The Environmental Protection Agency (EPA) has completed an evaluation of the Department of Energy's (DOE) requests of April 26, 2001, and June 29, 2001, to consider an alternative use of Panel 1 of the Waste Isolation Pilot Plant (WIPP). Based on our review of the information that you provided, and in accordance with section 194.4(b)(3)(vi) of the Compliance Criteria, we hereby inform you of our determination that DOE's proposed alternative use of WIPP Panel 1 is compliant with the terms and conditions of EPA's WIPP certification. Therefore, you may implement the following specific changes set forth in the April 26 and June 29 letters:

## **Enclosure: EPA Review of 4/26/01 and 6/29/01 Panel 1 Use Proposal**

## **Additional Information Needs on the Utilization of Panel 1**

Figure 1. Closure of Empty Storage Room (Morgan, 1987)

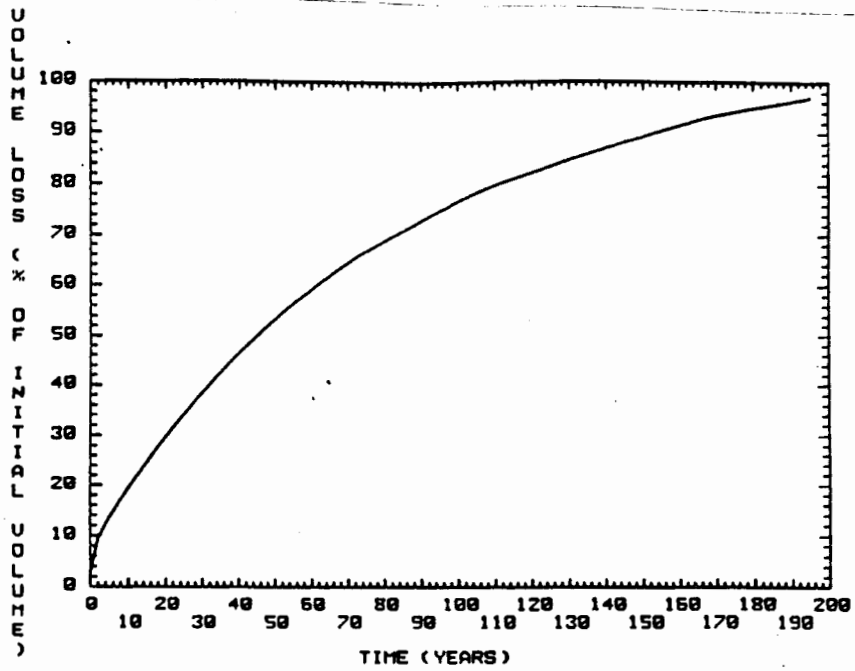
*"You state that, "If rooms are left open, they will close to a condition equivalent to unmined salt." (Section 3.5) Justify this assumption. What evidence do you have to support this conclusion?"*

*It is clear that you assume that an unused Room will close to become equivalent to unmined salt. Has your evaluation also considered the possibility that an empty room may act as a preferential pathway for fluid to enter the repository in the event of an intrusion borehole? Please explain how this scenario for intrusion is or is not plausible.*

Room closure can be quantified by geomechanical modeling. Response of the underground is conventionally modeled using the finite element method (FEM). Many pertinent analyses of waste rooms have been performed (e.g., Morgan, 1987, Callahan and DeVries, 1991 and Stone, 1997). Morgan's analysis of closure of an empty single room using SANCHO (a precursor of SANTOS) estimated total room closure in 195 years (Figure 1), without simulating the effects of roof collapse and floor heave. The analyses by Stone used the FEM code SANTOS. Figure 2 is a plot referenced by Stone, which illustrates room closure rates (although this particular calculation simulates the presence of WIPP waste in the room). Porosity is reduced to about 8% in approximately 100 years. As salt-backfilled rooms or empty rooms approach total closure, permeability will reduce asymptotically to values equivalent to those of intact salt ( $K < 10^{-19} \text{ m}^2$ ). This estimate of re-consolidated salt permeability (K) derives from a relationship between permeability and density, which was developed for the shaft seal system design (Sandia, 1996).
